# UTMC Errata Sheet

## UT69151 S $\mu$ MMIT<sup>TM</sup> RTE Auto Initialization

UTMC has identified the following deviation from intended functional operation for prototype and reduced high reliability versions of the UT69151 S $\mu$ MMIT RTE (device code MM022A).

**Figure 2. Auto-Initialization Read Cycle (MM022A)**

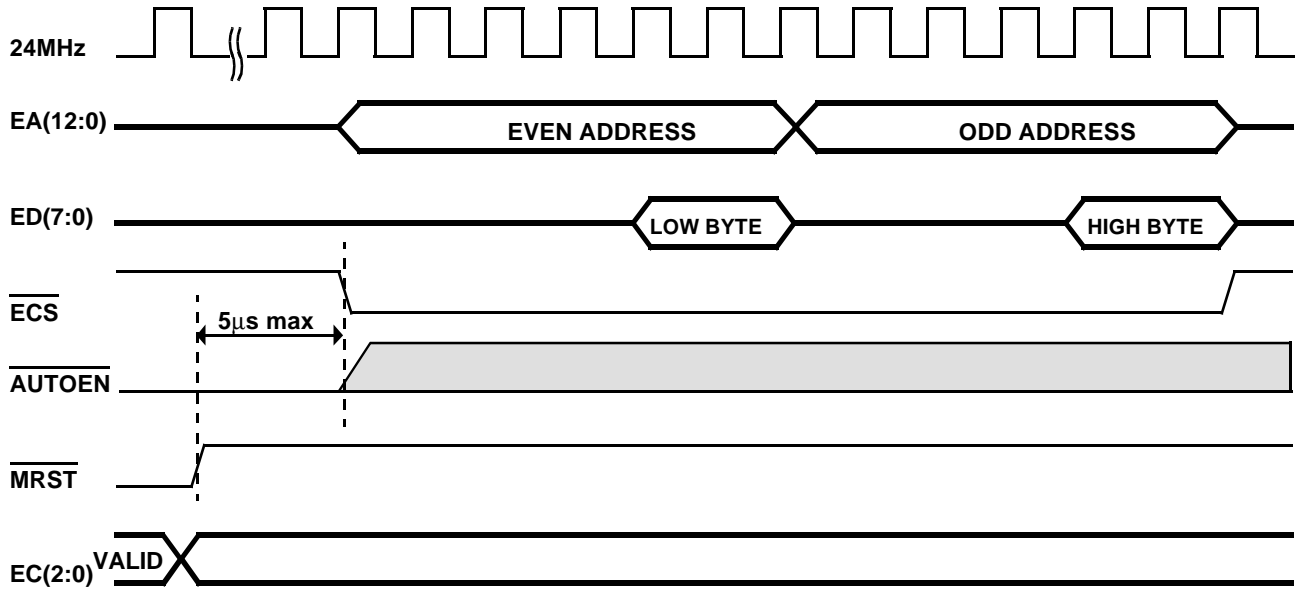
Evaluation has determined that the UT69151 SμMMIT RTE (MM022A) reads the auto-initialization memory in a reverse (i.e., low byte followed by high byte).

The production revision of the UT69151 SμMMIT RTE (MM022B) will incorporate a circuit change to the address circuitry such that the high byte is read first (i.e., resides of even addresses) followed by the low byte (i.e., resides on odd addresses). Production versions of the UT69151 SμMMIT RTE, with the design fix, are scheduled for end 4Q98 deliveries. A system work-around is to change the auto-initialization memory such that high bytes reside on odd addresses and low bytes reside on even addresses.
